## **A & E Professional Services Grant Funded Fish Passable Structures Questions and Answers**

Below are all the questions asked and answers given pertaining to the Request for Proposal for A & E for Design and Engineering of Fish Passable Structures from November 17– December 2, 2020

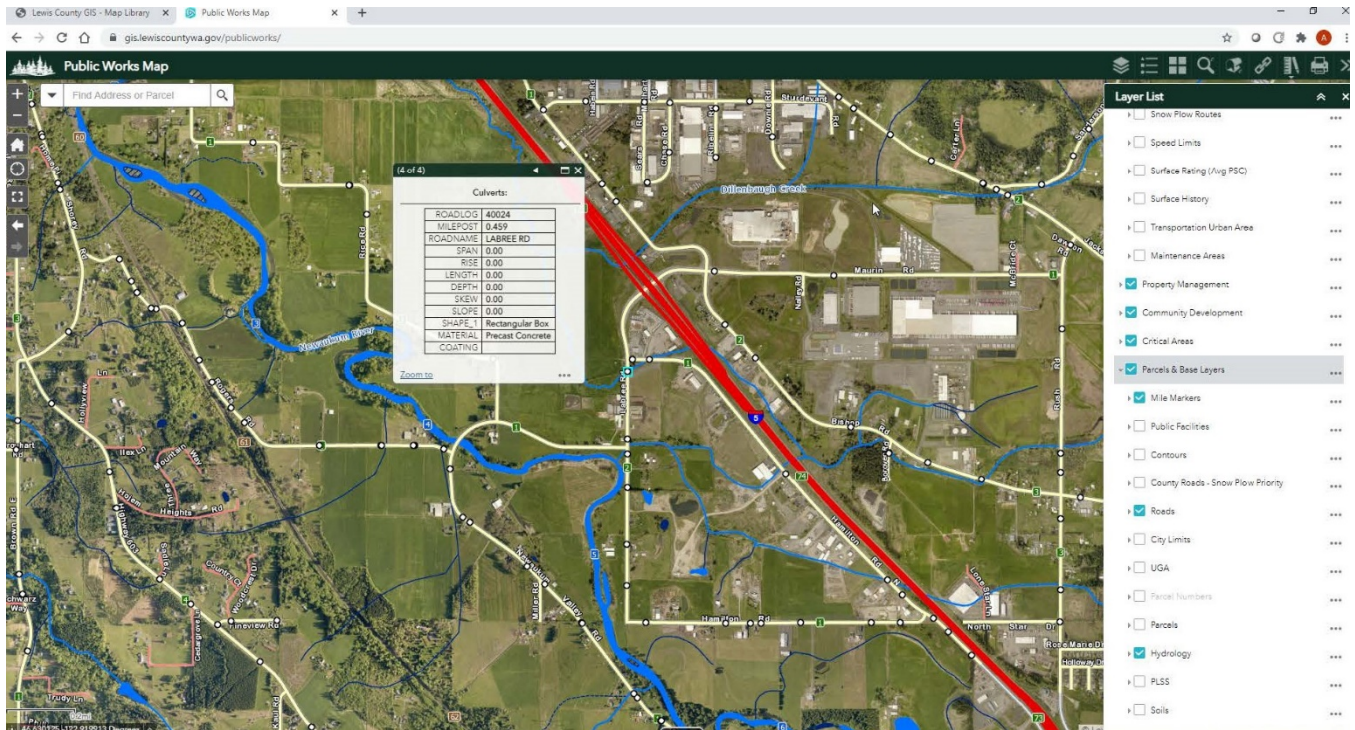
Could you confirm the culvert at MP 0.46 on Labree Rd is at the orange dot shown on the map in the RFP?  
*County records show the culvert at MP 0.459 is the one shown at the orange dot shown on the map in the RFP. This is also shown with a blue box around it on the map below.*
